## FLASH INFORMATION

### **ELYSTAR 50cc, 125cc, 150cc**

# <u>Subject:</u> SPEED READING ERROR FOLLOWING LIGHTING OF THE « CHANGE OIL » MAINTENANCE MESSAGE

DC 503 rev 1 dated 04/98 - QK 0001

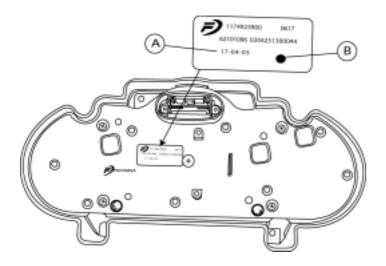
Identification of the new instrument clusters: On the back of the cluster on the label,

- if the date of manufacture (A) is before 17-04-03 and there is a spot of green paint at (B) the instrument cluster is serviceable.
- if the date of manufacture (A) is after 17-04-03 the instrument cluster is serviceable.

• if the date of manufacture (A) is after xx-xx-xx the instrument cluster is serviceable.
